Amendment No. 19  
License No. NPF-2

SAFETY EVALUATION BY THE OFFICE OF NUCLEAR REACTOR REGULATION  
SUPPORTING AMENDMENT NO. 19 TO FACILITY OPERATING LICENSE NO. NPF-2

JOSEPH M. FARLEY NUCLEAR PLANT, UNIT NO. 1

Figure 1 - Modification to Farley Nuclear Plant  
Service Water Recirculation System

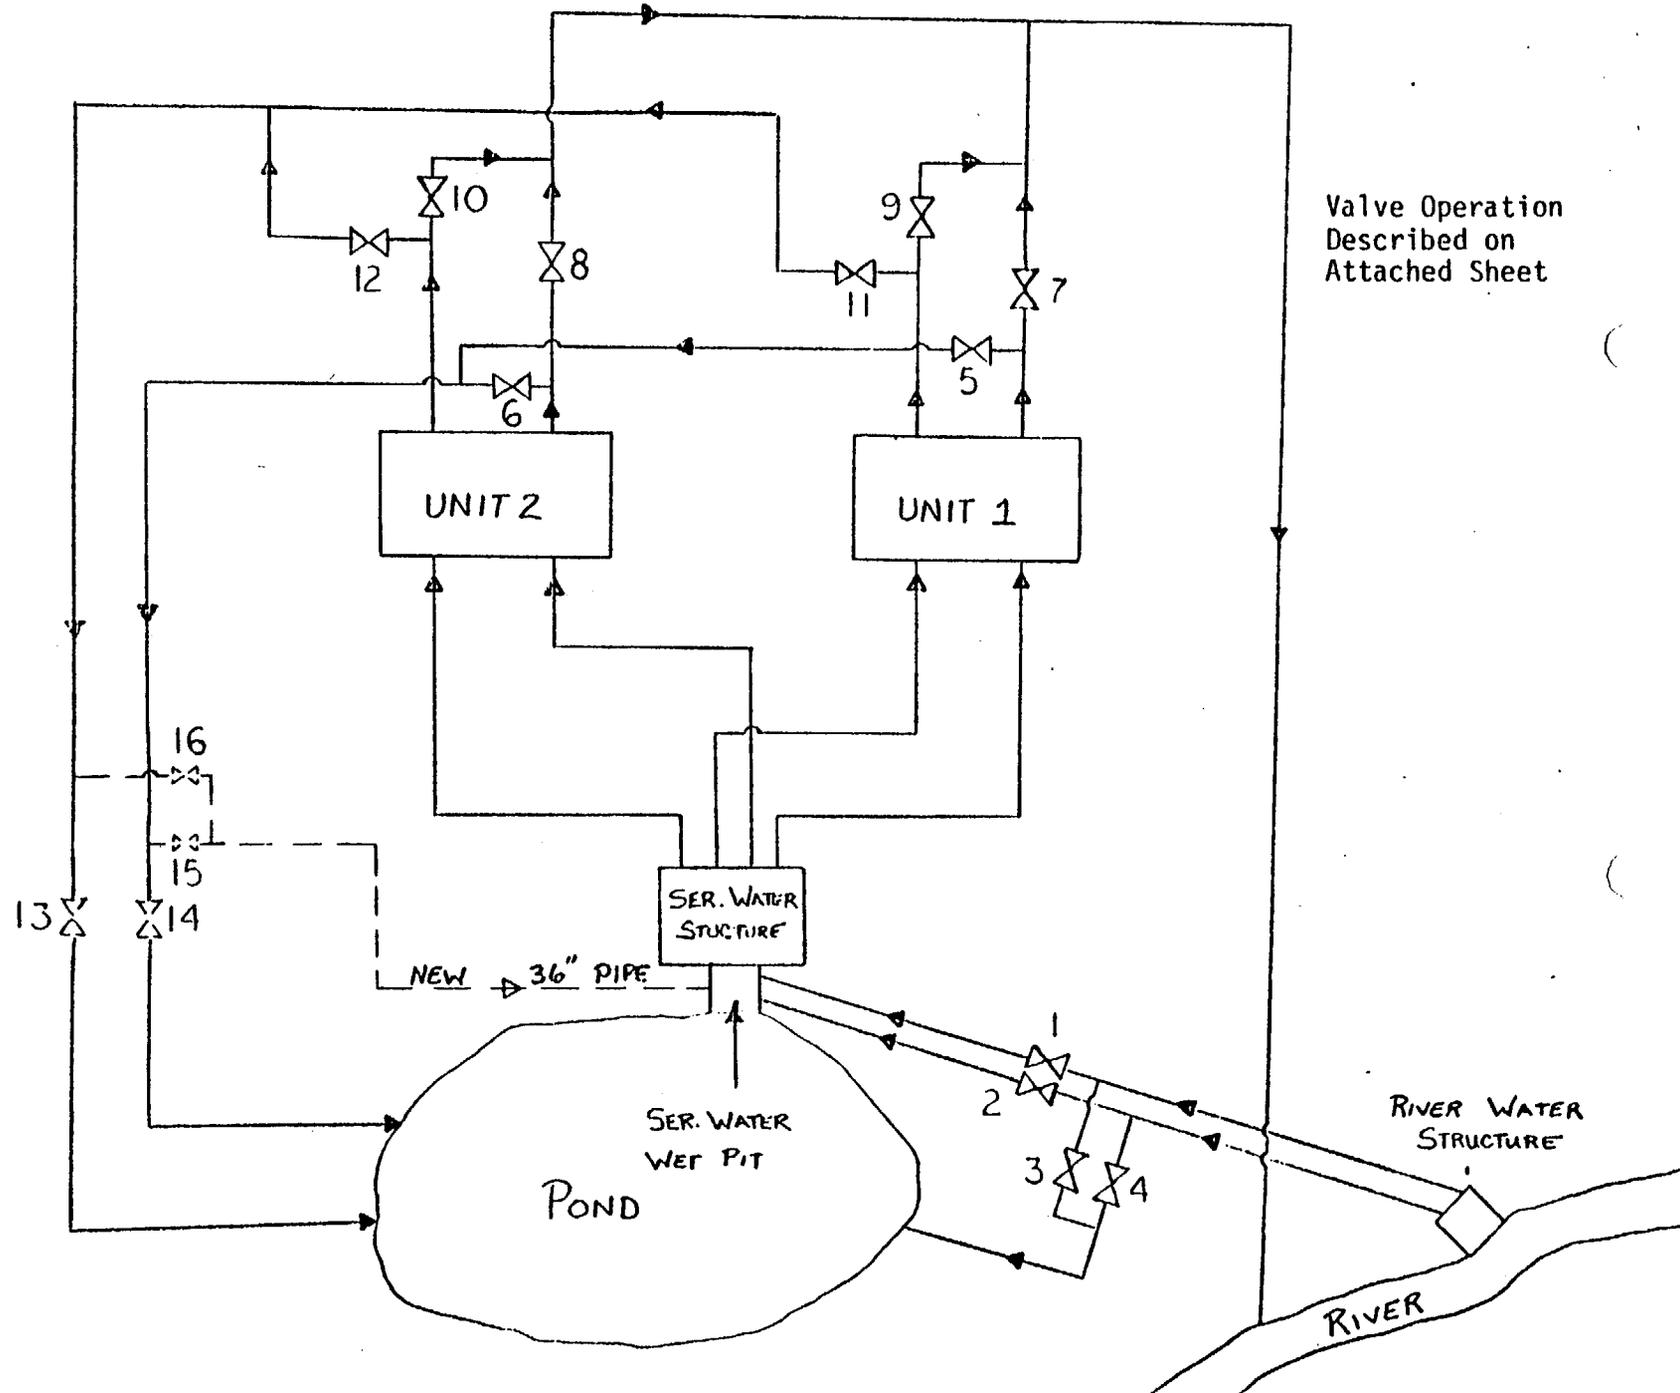
On March 24, 1981 the licensee reported a design deficiency in the service water system that was discovered during pre-operational flow tests for Unit 2. Farley FSAR Section 9.2.1.3 states that under a postulated accident condition involving a service water dam break, loss of offsite power (diesel generators would supply power to the river water and service water pumps), and the single most limiting active failure (e.g., loss of one train of river water), the operator would have 30 minutes before action would be required. During this 30 minute span a flow mismatch would exist in the wet pit as four river water pumps are postulated to serve eight service water pumps. If the operator does not take action to terminate service water flow to non-essential systems, the wet pit water level would decrease until the service water pumps would develop NPSH problems.

The eight service water pumps serving both units require approximately 53,000 gpm. Pre-operational flow tests by the licensee showed that the combined flow capacity of four river water pumps was over-estimated. Tests showed a combined capacity of approximately 43,000 gpm which would necessitate operator action in 20 minutes before service water pump problems would initiate.

On March 24, 1981, the licensee proposed modifying the service water systems by adding valves 13, 14, 15 and 16 and the new 36" line shown on the attached figure. When water levels in the service water wet pit reaches a pre-determined low level, instrumentation will now automatically open valves 5, 6, 11, 12, 15 and 16 and will automatically close valves 7, 8, 9 and 10. This action terminates service water flow directly to the river and diverts flow to the service water wet pit. Valves 13 and 14 will automatically close to a throttle position so that service water discharged from the two units will go to both the wet pit and the pond. The additional flow to the wet pit provides more than 30 minutes before operator action is required to balance the service water and river water flows.

The licensee has made very conservative assumptions to create the need for this Technical Specification change. The postulated scenario includes loss of the pond's dam which has been designed to withstand both the design basis seismic event (seismic Category 1) and the probable maximum flood coupled with waves, loss of offsite power and the worst case single active failure which would be the loss of one river water train. The previous FSAR analysis stated that under this scenario the operator would have 30 minutes to correct the river water/service water flow mismatch in the wet pit. Due to over-estimated river water flow with four pumps running, the licensee predicts that only 20 minutes would be available before action is needed. The proposed modifications automatically diverts service water back to the wet pit and the operator once again has over 30 minutes to take action.

While the modifications are being performed, only one train returning to the pond will be inoperable at a time. It is important to note that the return line that will be temporarily inoperable is normally closed. Both units will continue to be served by both trains of service water. Prior to modifications both trains of river water will be verified to be operable and the licensee will not initiate any modifications if there is a forecast of unusual river water flows which could possibly impair river water operability.

We consider that the possibility of a combined dam failure, loss of offsite power and failure of a river water train is remote. The possibility of this occurring within the ten day extension to the Technical Specification action statement is even more remote. Even if all of the above does occur, the operator will have 20 instead of 30 minutes to correct the flow mismatch in the wet pit by isolating non-essential service water systems. The plant operators have received special training to prepare themselves for this possibility.

We have reviewed the proposed Technical Specification change and find it to be acceptable with minor changes agreeable to the licensee. We have examined the proposed modifications to the service water system and conclude that they will be adequate to perform the system function. We agree that the modification schedule of completion about May 15, 1981 is satisfactory.
